BLAISE AD HAZOP

RMD-02-004

An interface HAZOP study was undertaken at BioConstruct's offices at Stockton-on-Tees, Teesside on 3rd June 2019, commencing on 4th June and being completed on 9th July, on the design of the proposed Anaerobic Digestion Facility for Crofthead.

This report details the findings of the HAZOP Study. The drawings used in the HAZOP study are found in the Drawings Section of this report and are based upon the following P&IDs:

Node 2

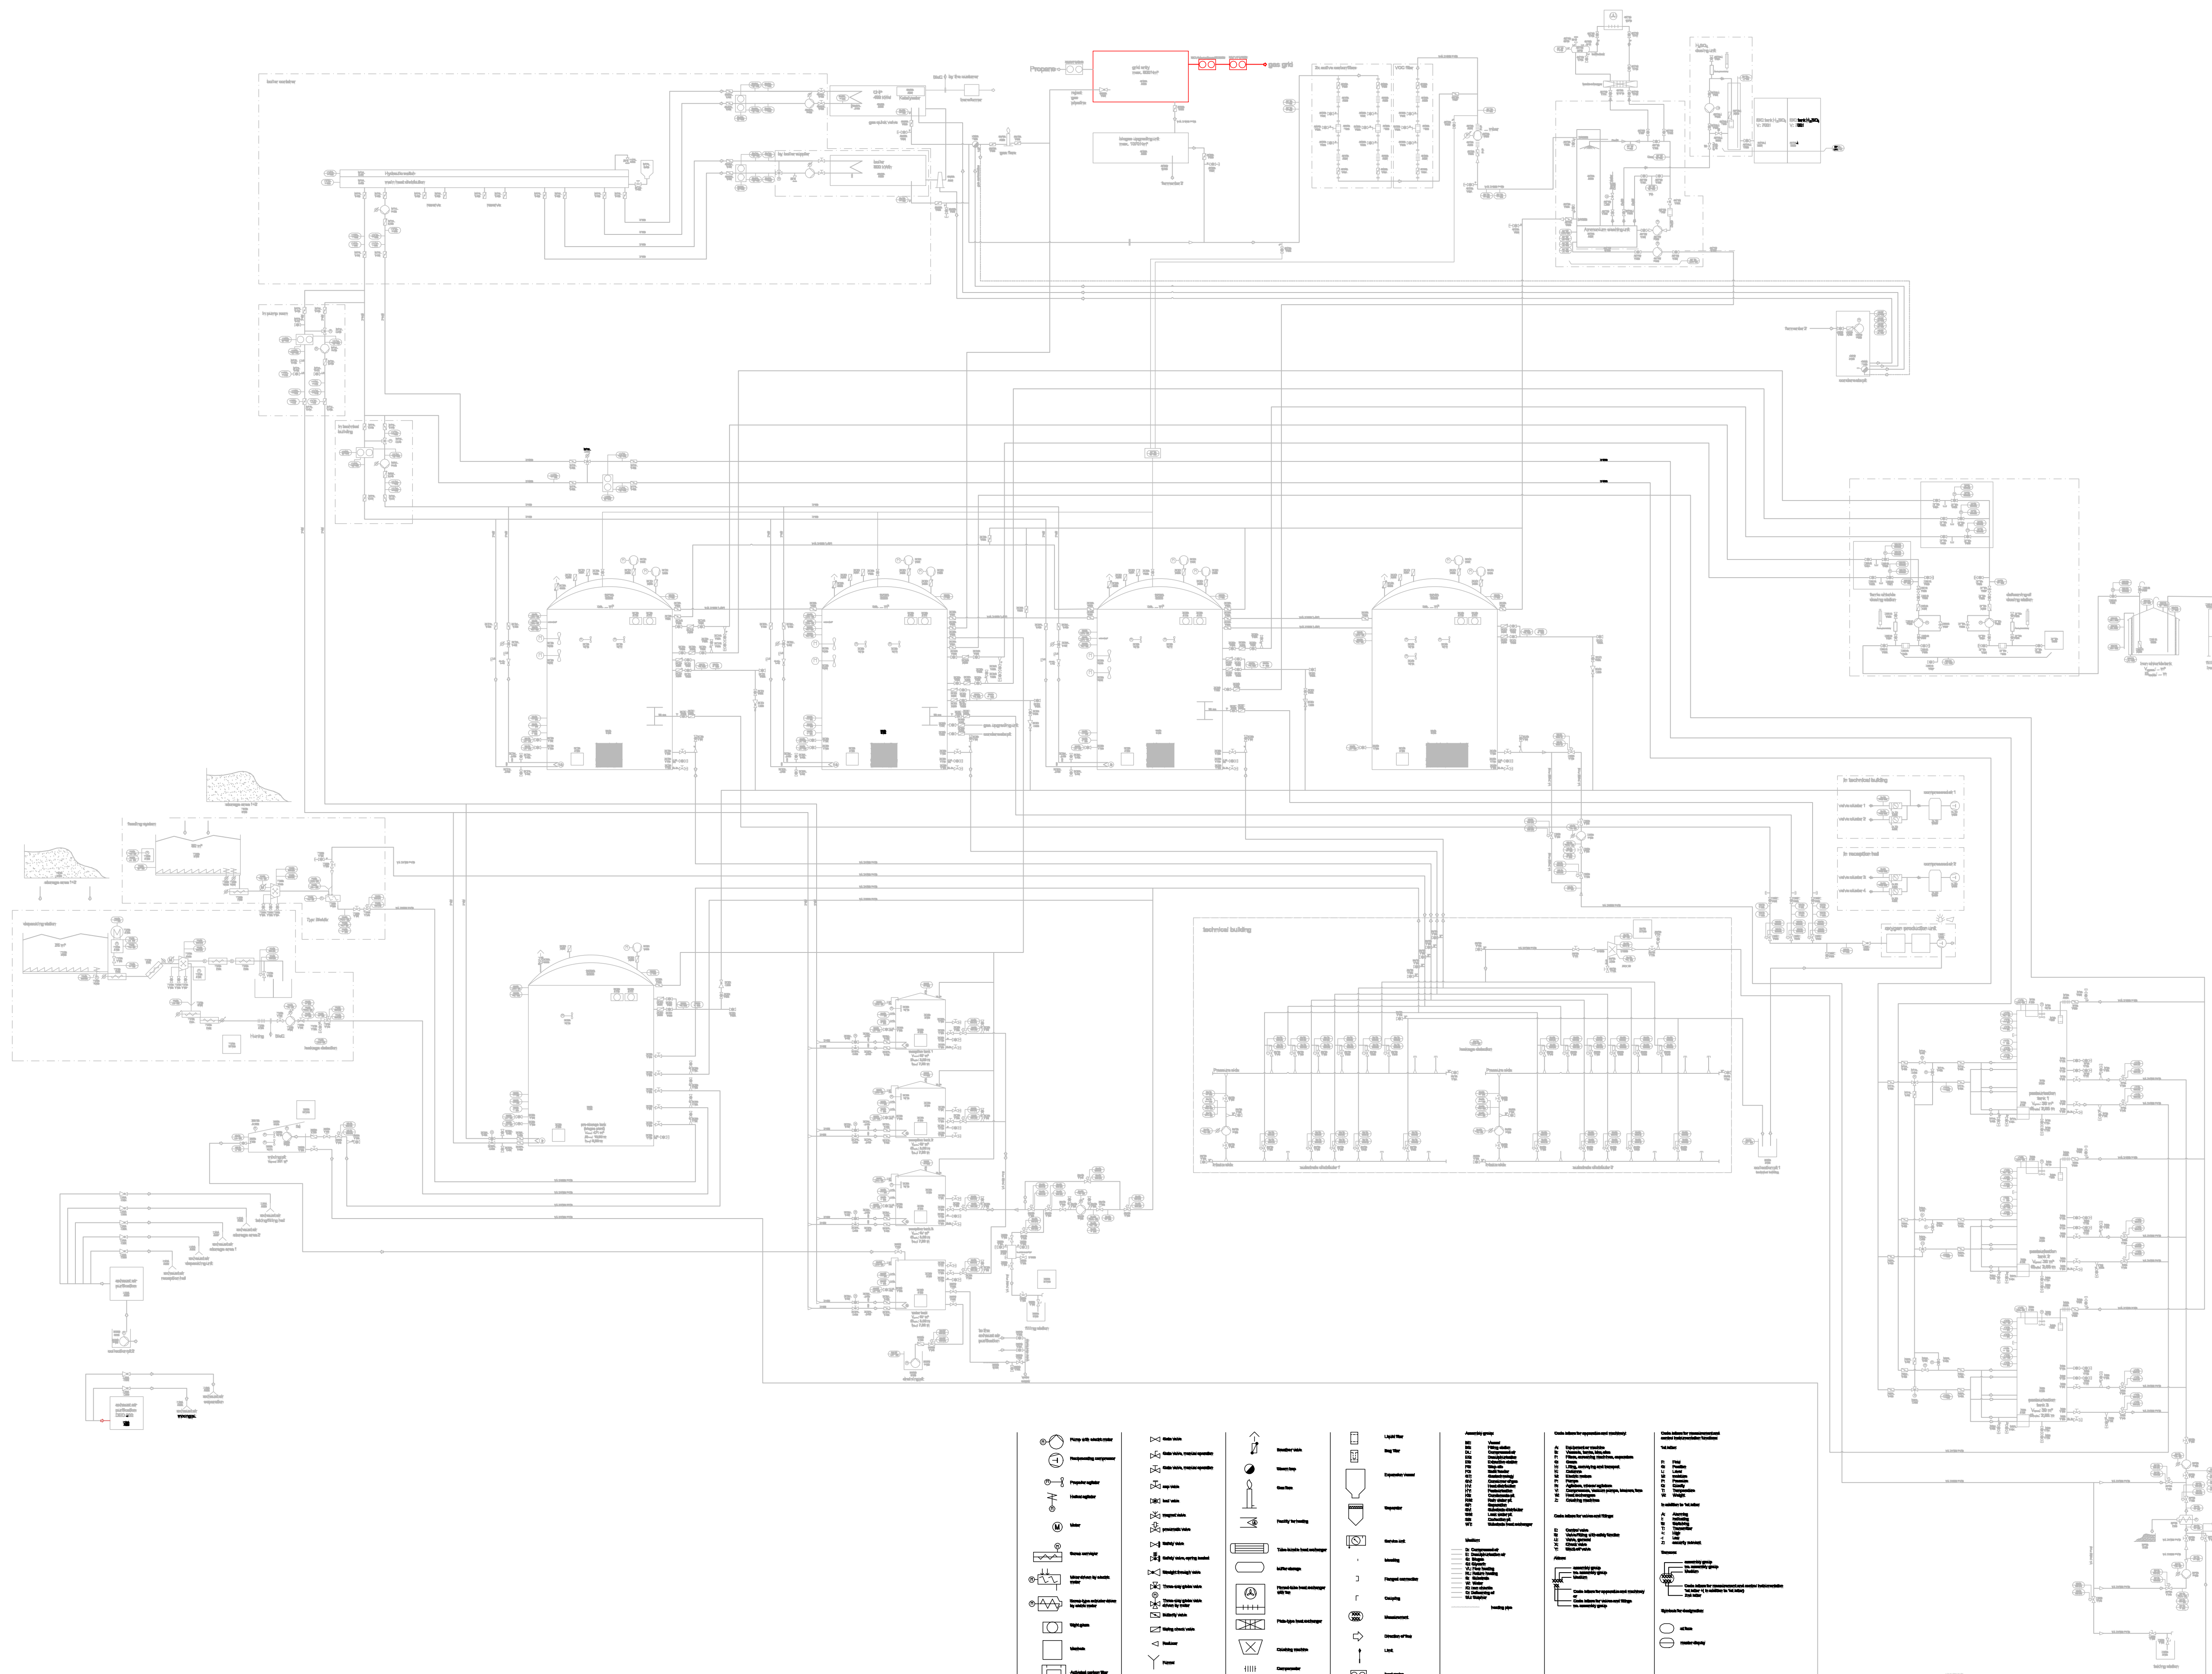
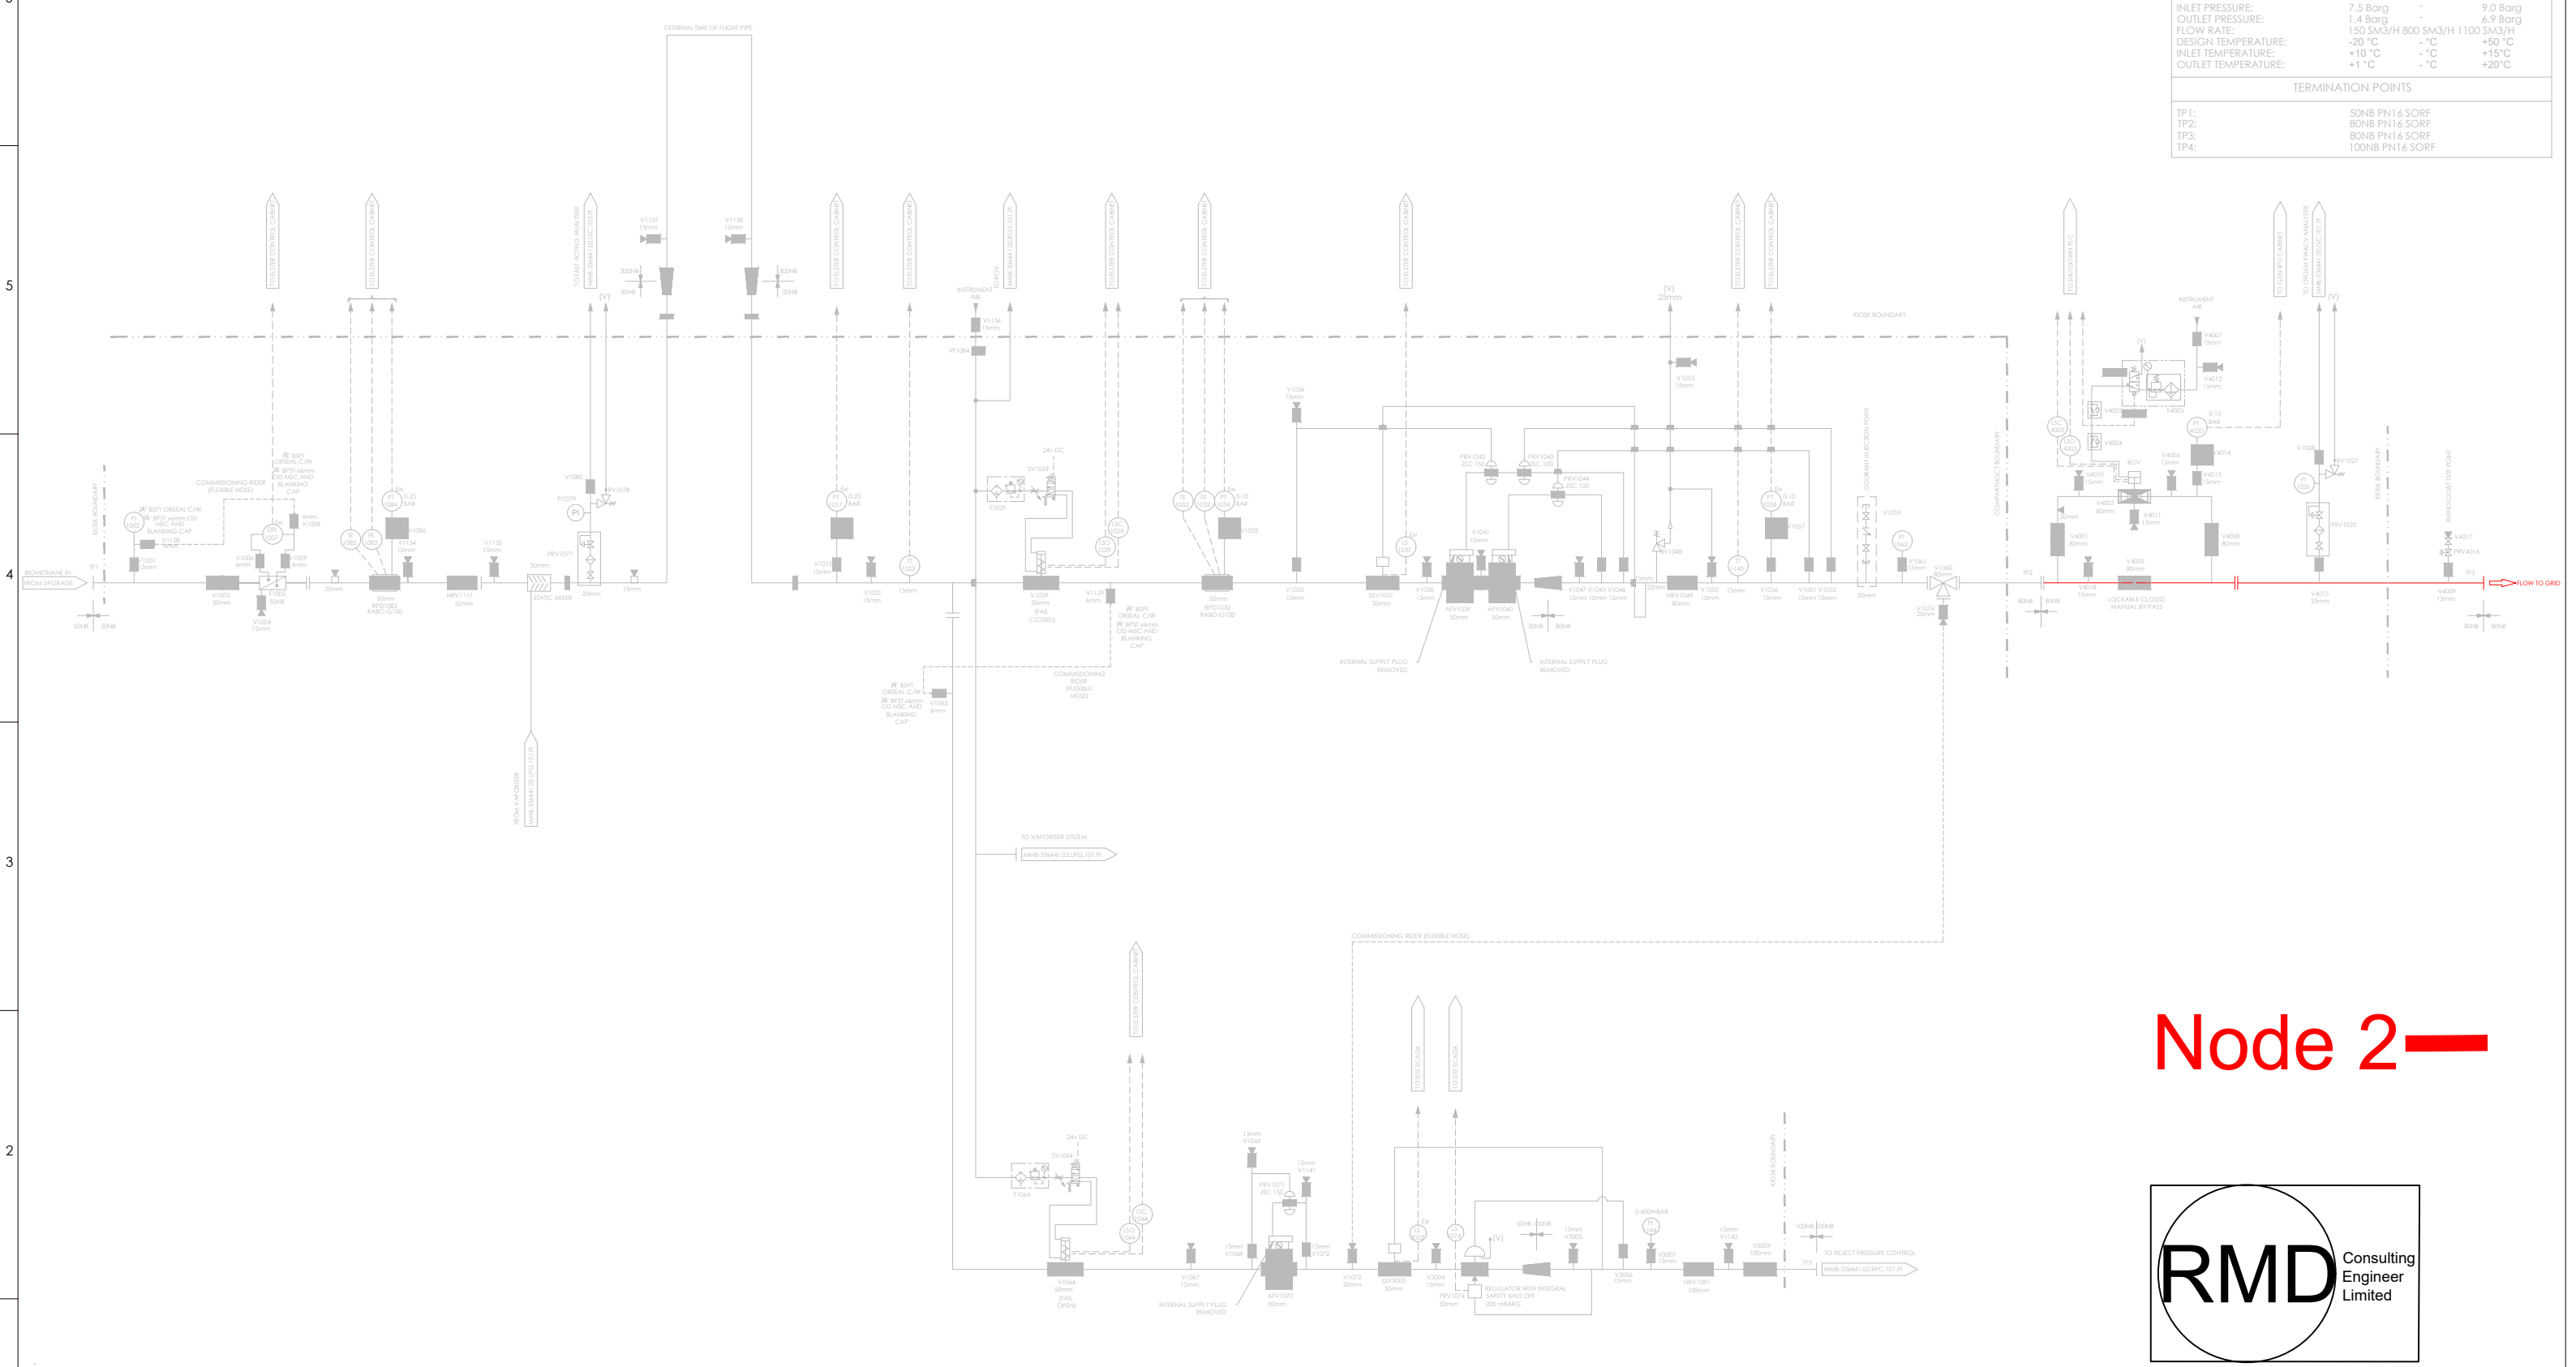
| ID/No. | Deviation | | No. | Possible Causes | Consequence | Safeguards | No. | Actions Required | Action Allocated to |
|--------|------------|-----------|-------|---|--|--|-----|------------------|---------------------|
| 2.1 | No | Flow | 2.1.1 | Poor biomethane quality | <ul style="list-style-type: none"> The Elster unit goes to reject to flare - 20 minute reject to allow gas quality to improve, inefficient operation | <ul style="list-style-type: none"> Gas analysis in the AD facility to monitor gas quality fed to BUU BUU CH4 measurement to ensure correct purity fed to Elster unit Realtime monitoring of biomethane quality within Elster unit allows adjustment of propane to maintain CV OFGEM analyser on outlet measures full biomethane quality | | | |
| | | | 2.1.2 | The ROV is shut | <ul style="list-style-type: none"> The Elster unit will reject to flare After 20 minutes a "not available" signal sent to Elster to Pentair - Pentair unit shuts down and bleeds back to the AD biogas line to relieve pressure - approximately 2 hours gas storage buffer within the AD facility at normal operation Potential flaring of biogas | <ul style="list-style-type: none"> Poor gas quality (see 2.1.1) Loss of communications (see 2.1.3) | | | |
| | | | 2.1.3 | Loss of communications | <ul style="list-style-type: none"> Closure of ROV and reject to flare (see 2.1.1 & 2.1.2) | <ul style="list-style-type: none"> 2 methods of communication, satellite link and backup telephone line - 4 minute lag to allow either satellite link to be restored or telephone line communication to synchronise | | | |
| | | | 2.1.4 | Interference damage on grid | <ul style="list-style-type: none"> Inability to inject to grid requiring divert to flare If catastrophic damage to gas main ROV will operate and reject to flare from Elster unit | <ul style="list-style-type: none"> A valve chamber available to SGN engineers to allow fitting of a valve rider governor which can be fitted to facilitate pressure reduction | | | |
| | | | 2.1.5 | Loss of propane | <ul style="list-style-type: none"> Biomethane quality unable to meet CV target - unable to inject to grid (see 2.1.1) See Node 4 | <ul style="list-style-type: none"> See Node 4 See 2.1.1 | | | |
| | | | 2.1.6 | High inject differential pressure compared with grid pressure | <ul style="list-style-type: none"> Unlikely scenario | | | | |
| | | | 2.1.7 | No flow from BUU | <ul style="list-style-type: none"> Inability to inject to grid (see Node 1) | <ul style="list-style-type: none"> See Node 1 | | | |
| | | | 2.1.8 | Power failure (including lightning strike) | <ul style="list-style-type: none"> Unable to inject gas to grid thus reject to flare approximately 2 hours gas storage space in normal operation before requirement to reduce pressure through flaring | <ul style="list-style-type: none"> Battery pack capable of maintaining 8 hours instrument life for SGN RTU (remote telemetry unit) 2 hour battery pack for controlled shutdown of grid entry unit Battery pack for Coms and instrumentation within AD facility Automatic start-up of backup generator on AD facility to maintain critical plant and equipment including the flare Lightning risk assessment (see DSEAR assessment) | | | |

| ID/No. | Deviation | | No. | Possible Causes | Consequence | Safeguards | No. | Actions Required | Action Allocated to |
|--------|------------|-----------|--------|---|---|--|-----|------------------|---------------------|
| 2.1 | No | Flow | 2.1.9 | Failure of LGT (odour unit) | <ul style="list-style-type: none"> Potential to inject un-odorised gas into network - not GSMR compliant | <ul style="list-style-type: none"> Low level alarm on the odorant, alerts operator to refill - operator decants to onboard reserve tank and new bottle ordered for delivery(approximately 7-10 days minimum capacity within reserve tank) Flow meter measures odorant injection Measure odorant injection pump strokes and calculate flow - if pump strokes or flow measurement inconsistent then alarm and send to divert | | | |
| | | | 2.1.10 | Biomethane temperature outside specified range in NEA (0-20 degrees maximum) On start-up high or low ambient temperature Failure of Pentair chiller | <ul style="list-style-type: none"> Inability to inject to grid - divert to flare Potential damage to gas main | <ul style="list-style-type: none"> Temperature measurement within Elster unit TT1023 ensures high temperature or low temperature biomethane is diverted Temperature measurement from TT1140 ensures temperature to grid within specification and diverts when outwith specification 10 minute period granted by SGN on start-up to allow temperature to fall within range | | | |
| | | | 2.1.11 | Compressed air failure | <ul style="list-style-type: none"> Inability to operate valves - potential unsafe scenarios, increased fire and explosion risk | <ul style="list-style-type: none"> Compressor reservoir allows sufficient capacity to shutdown plant in a controlled manor Valve to reject fails open ROV and gas to grid valve fail closed Propane valve fails closed Low pressure switch in Pentair compressor alarms Potential to connect to BioConstruct compressed air system if required | | | |
